511 Capitol Building Stabilization Project IOWA CITY, IOWA 10271-10004

ADDENDUM 02

December 2, 2025

This addendum forms a part of the Contract Documents and modifies the original bidding documents dated November 14, 2025, as noted below.

E-103

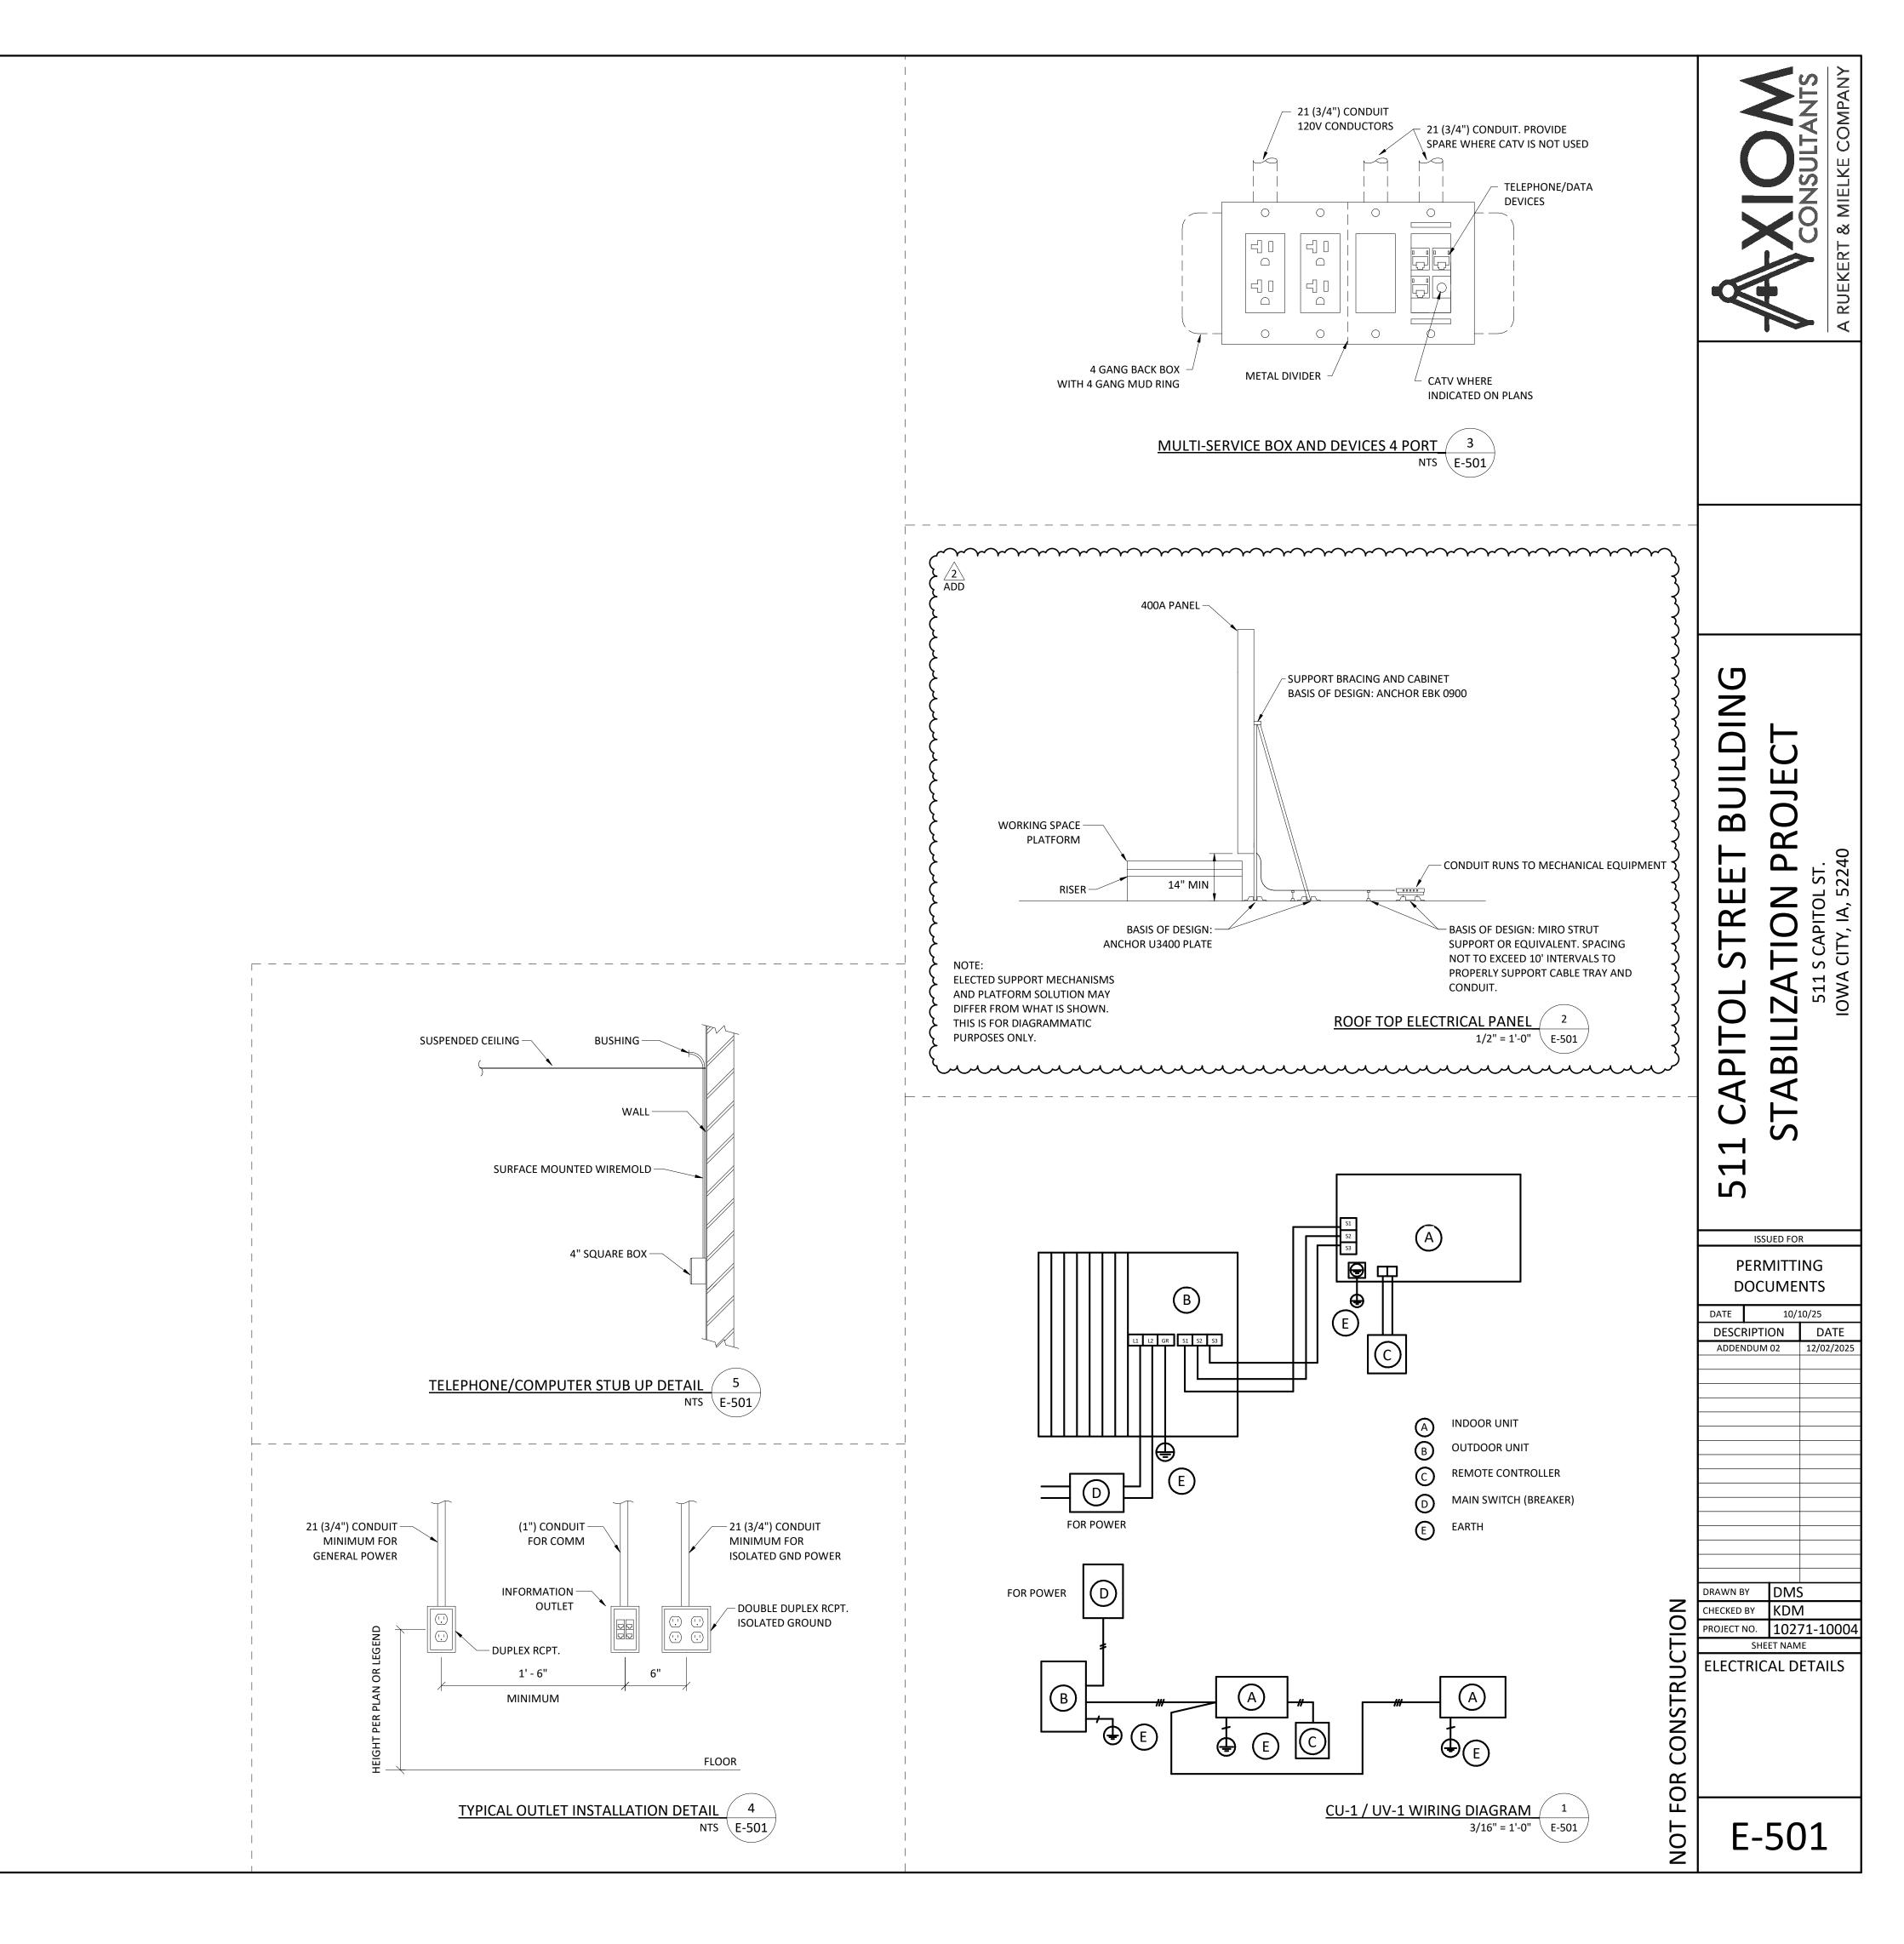
- 4. ADD Electrical Keyed Notes.
- 5. REVISE rooftop chiller control panel wiring.
